## E8356A-03

# S E R V I C E N O T E

## E8356A PNA Microwave Network Analyzers

**Figure 1:** A3 Front Panel Interface Board Assy without the Bracket

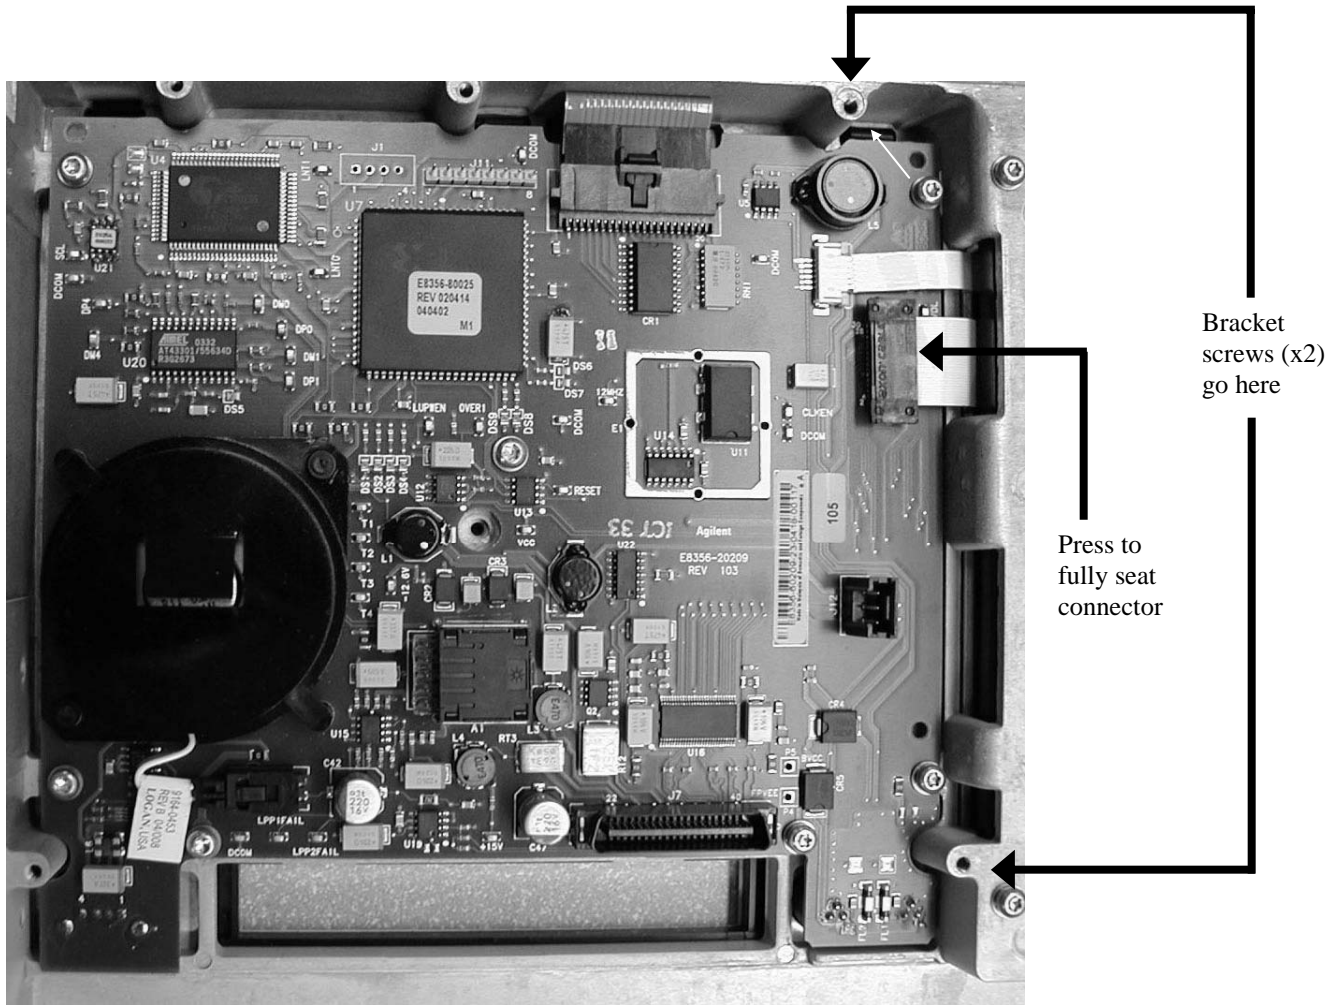
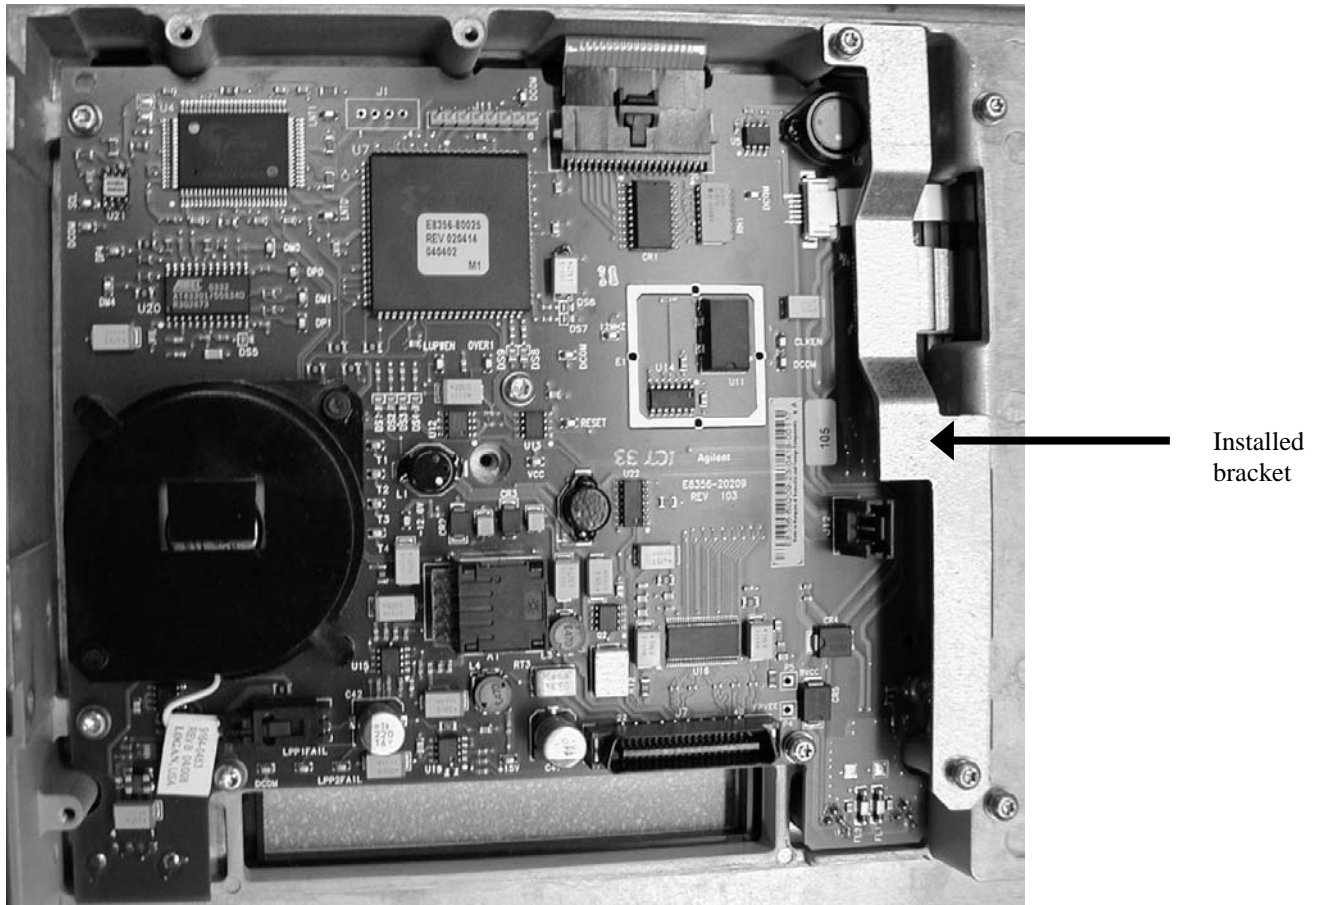
A connector of the ribbon cable (Agilent part number 8120-8409) that joins the front panel display to the front panel interface board can loosen, causing a display failure, unless a new bracket is installed. Because the failure rate has been very low, it is recommended that the bracket be installed only when there is an additional reason to remove the PNA front panel.

1. Refer to Figure 1 in this document:
  - Press down firmly on the ribbon cable's black connector.
  - Locate the two tapped holes for the bracket screws.
2. As shown in Figure 2 in this document, position the bracket so that its holes line-up with the two holes you located in the previous step.
3. Hand-start the two screws, and then torque both to 9 in-lbs.
4. Reinstall the PNA Front Panel by following the Service Guide instructions in the "Replacement Procedure." This is located on the same page as the "Removal Procedure" used previously in step 7.
